RECEIPT DATE: 3/23/17 **ONSITE SEWAGE DISPOSAL SYSTEM** P 560580-1

RE: Vista Ridge Lot 13
2046 Drovers Lane
Cooksville, MD 21723
"BAT Plan & Site Plan"

DATE	10/20/16	PROJECT No.	1635
ATTENTION	Robert Freeman		
RE:	Vista Ridge Lot 13		
	2046 Drovers Lane		
	Revised BAT Plan

TITLE: SEPTIC PERMIT SITE PLAN

TITLE: BUILDING PERMIT PLAN AND BAT SITE PLAN

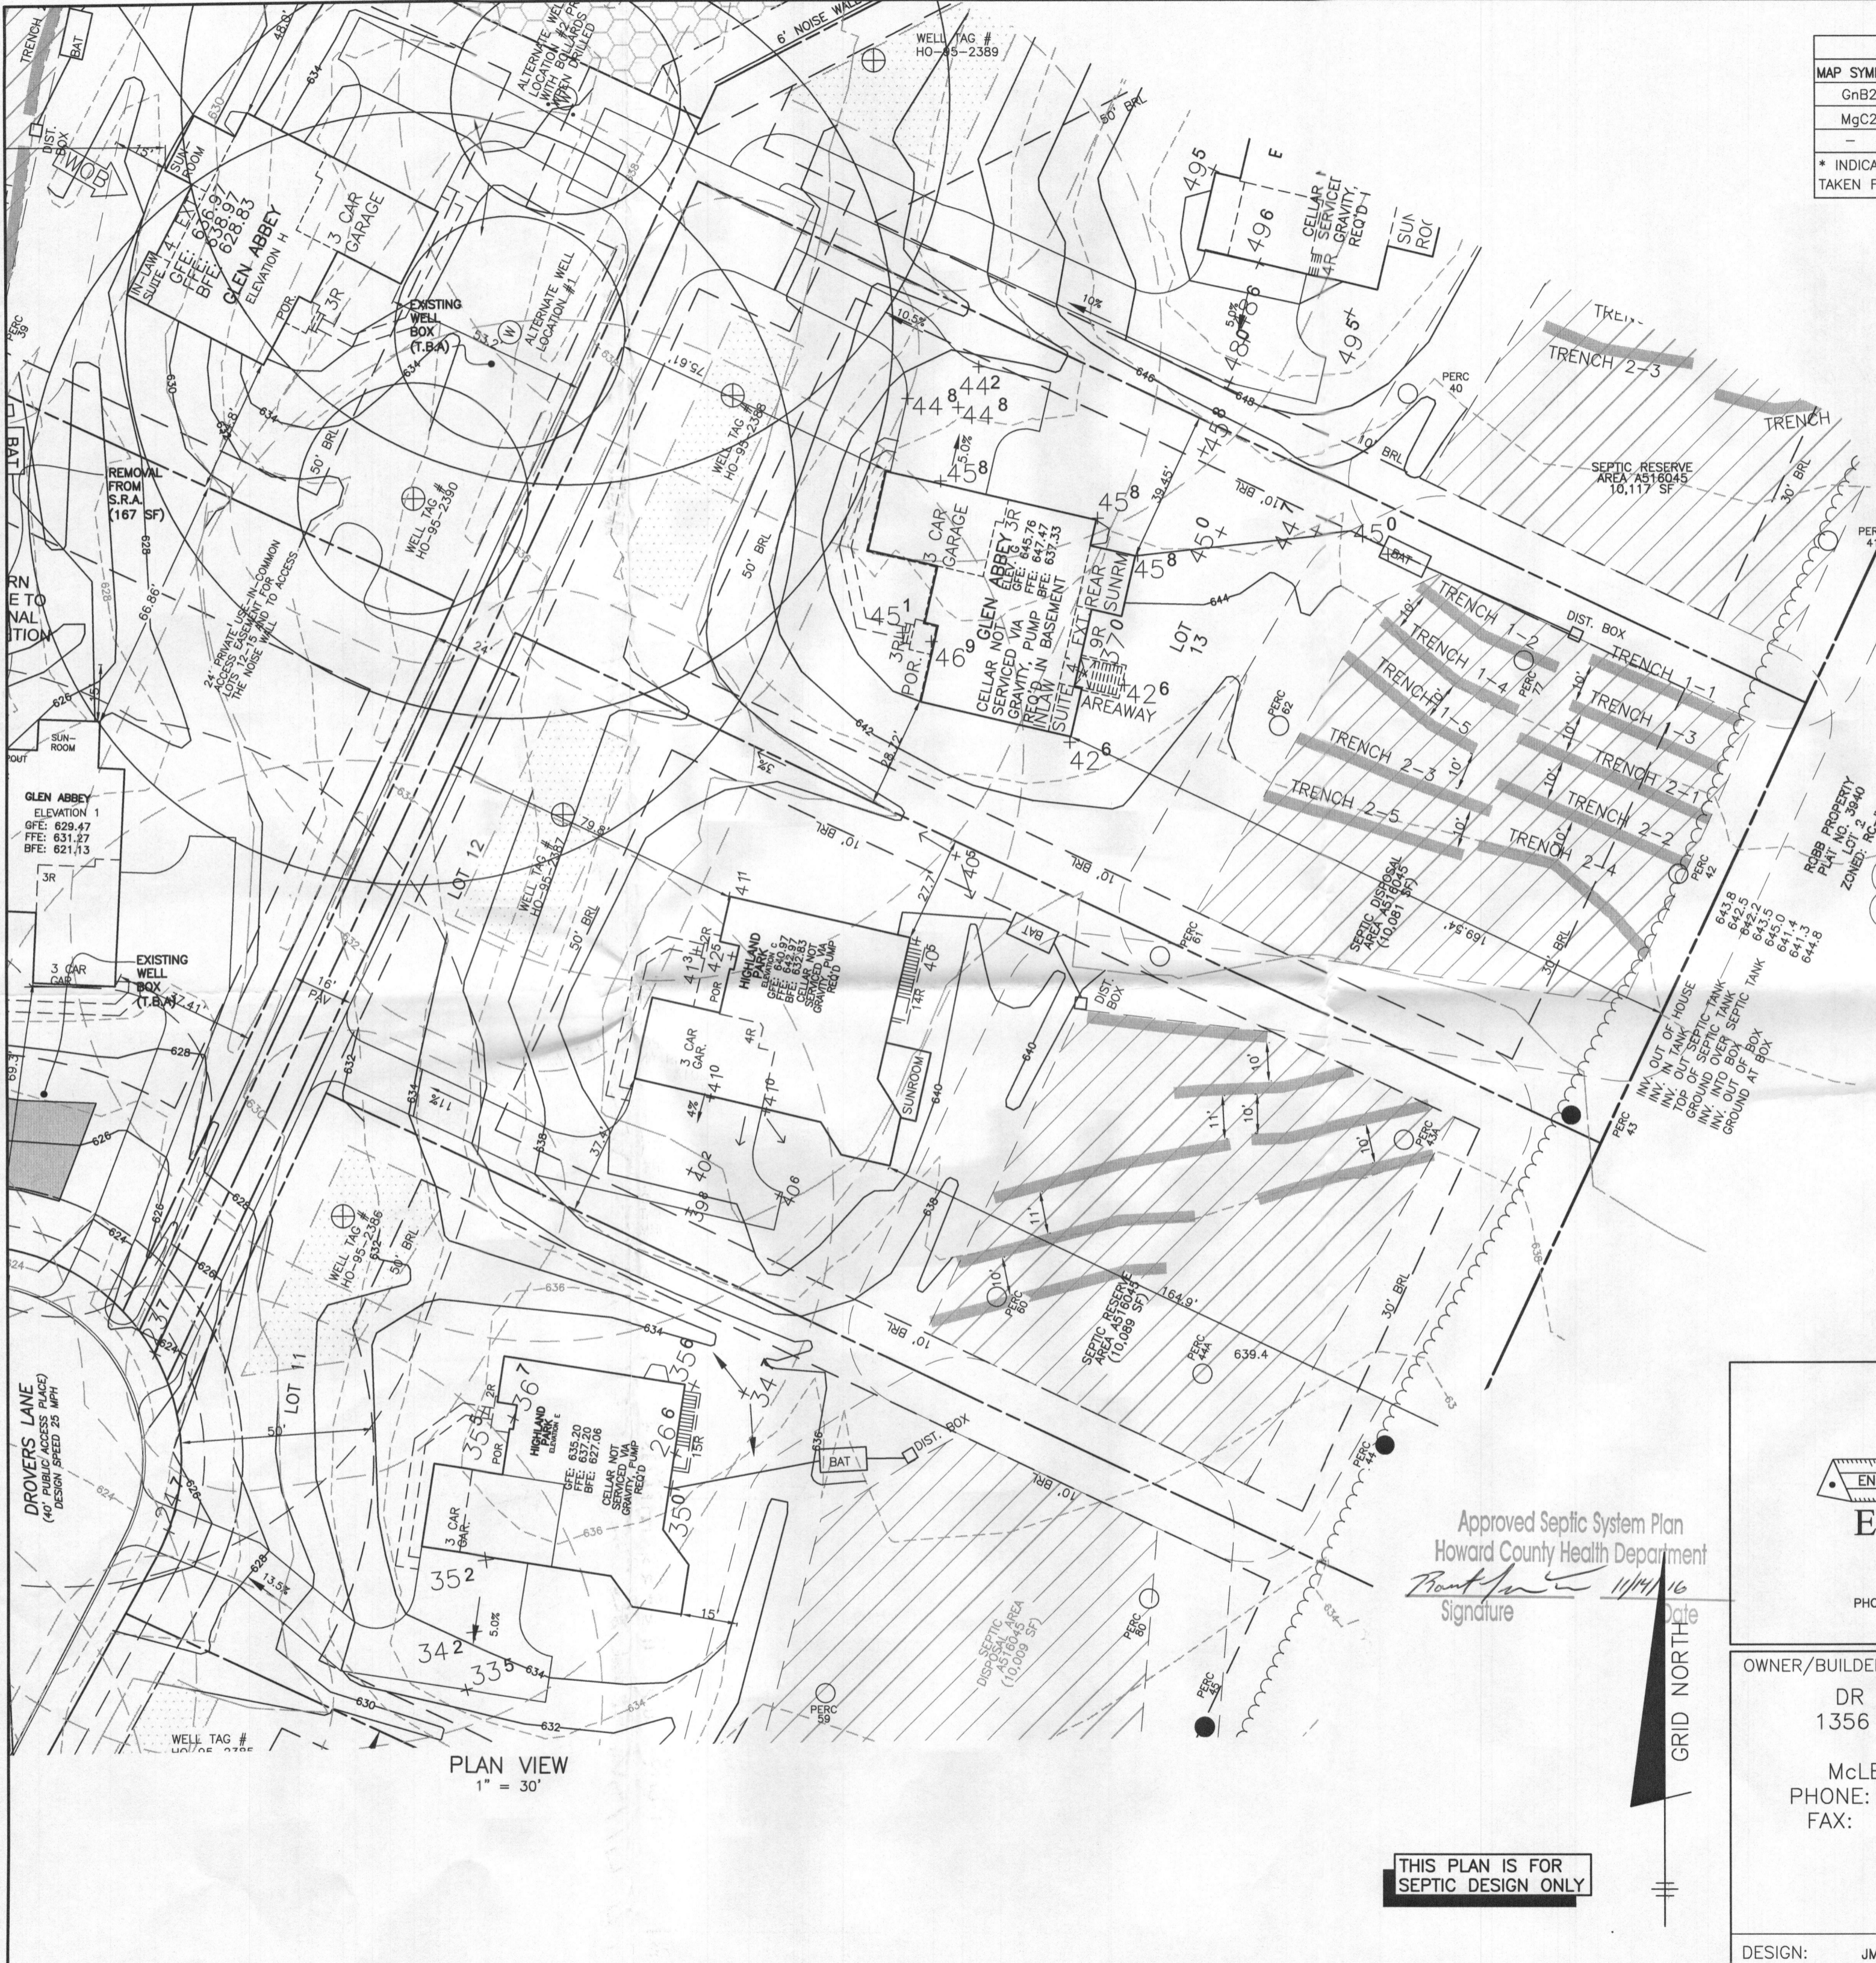
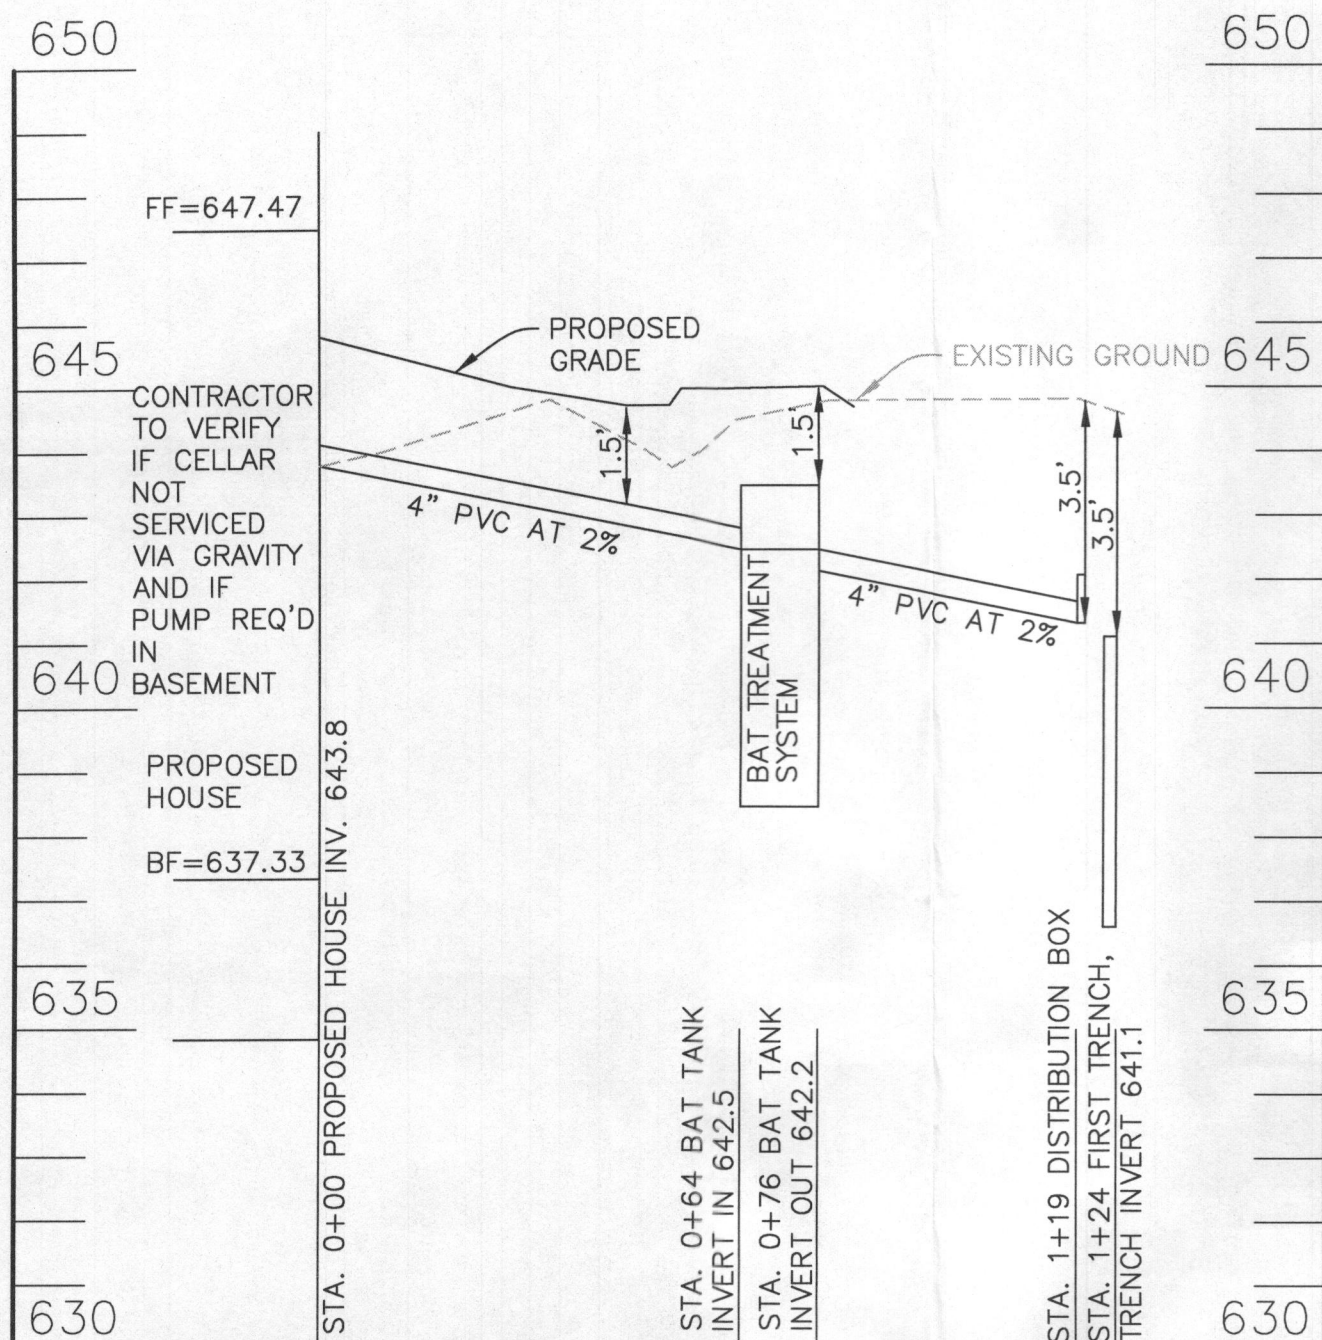
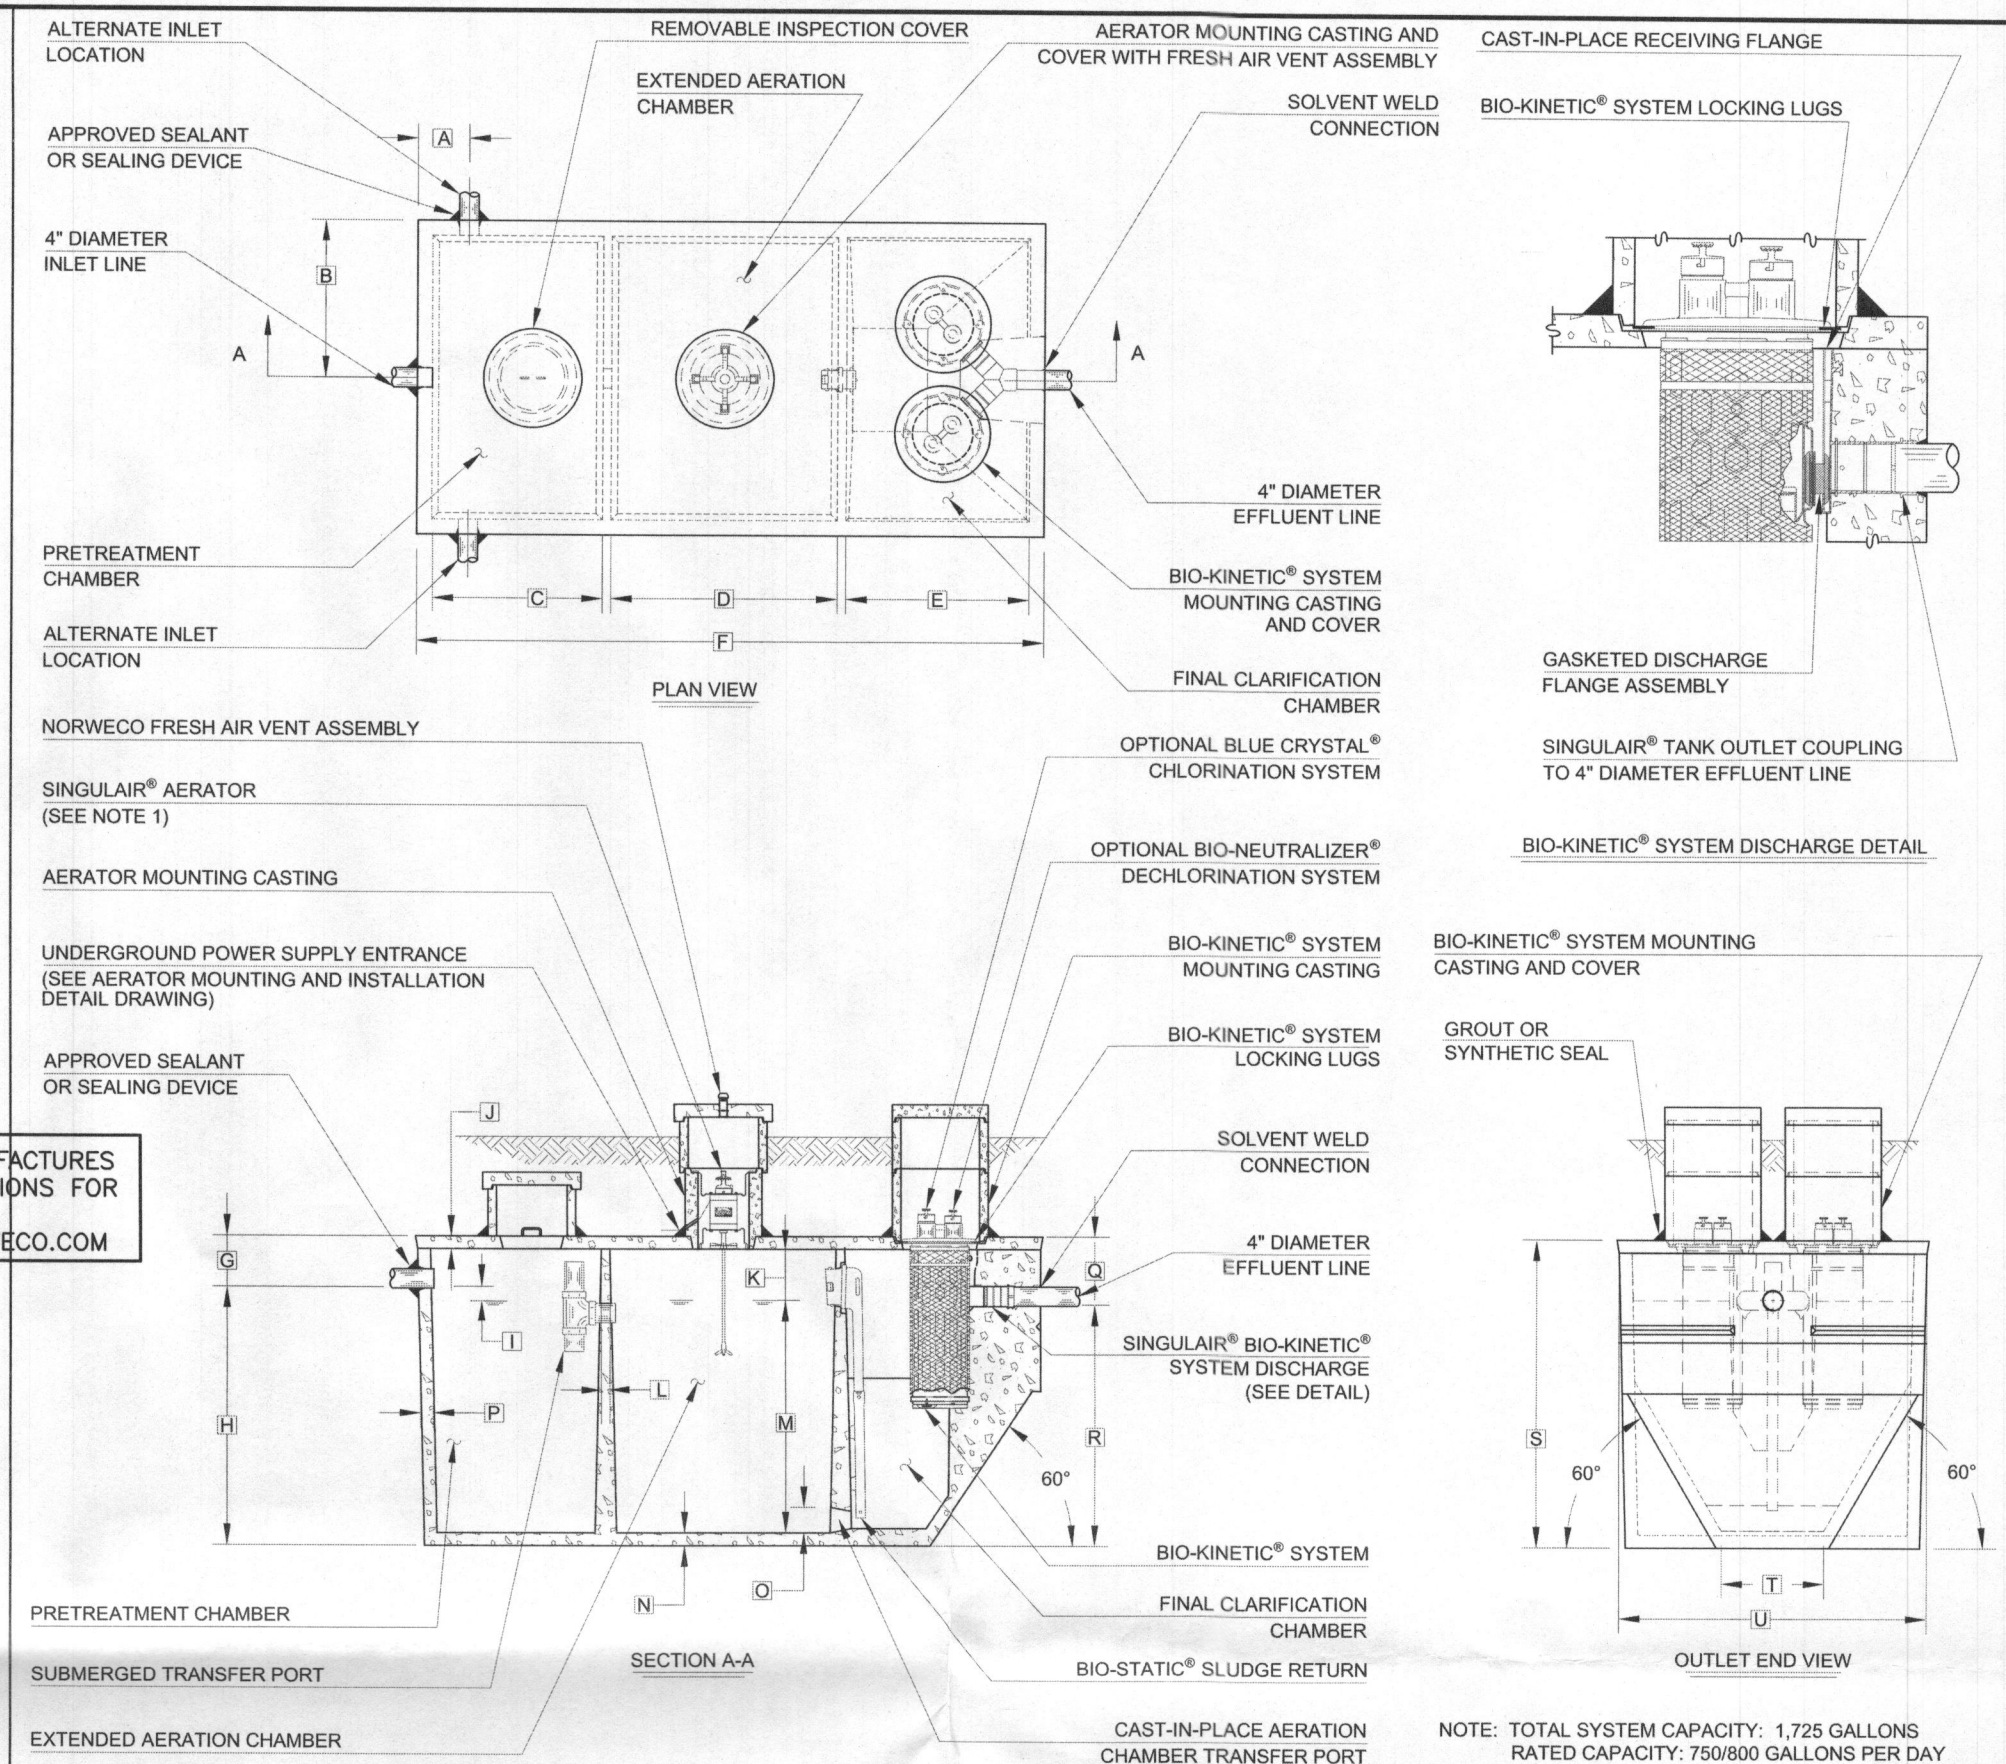
Here are my comments after reviewing the BAT Plan and Site Plan for Vista Ridge Lot 13.

- The engineer's seal and signature needs to be present on the 1st page as well as the 2nd page.
Approved Norweco BAT units appropriate for this plan could include the Singlair Model TNT 750 or the Singlair Model TNT1000. The Singlair Model 960LP-750 is not recognized as an approved unit.
The components of the septic system need to be repositioned in order to maximize space and soil filtration efficiency. The BAT unit can be shifted north east to the outside edge of the SDA away from the swale. The distribution box can also be shifted to the outside edge of the SDA. The initial trenching system could be divided into 5 x 42' length trenches and laid out along contour spanning the whole northern end of the SDA. The 2nd trenching system could be divided into 5 x 54' length trenches and laid out along contour below the first set of trenches.
A new site plan will need to be created and submitted to DILP as a Revised Site Plan.

REMARKS: ① Seal & Signature added to sheet 1.  
 ② TMTLP-750 GPD tank specified.  
 ③ Components adjusted as required. Trench design is per your design. ④ Septic permit should be per this plan, no building permit plan/inspection changes so no new building permit plan necessary.
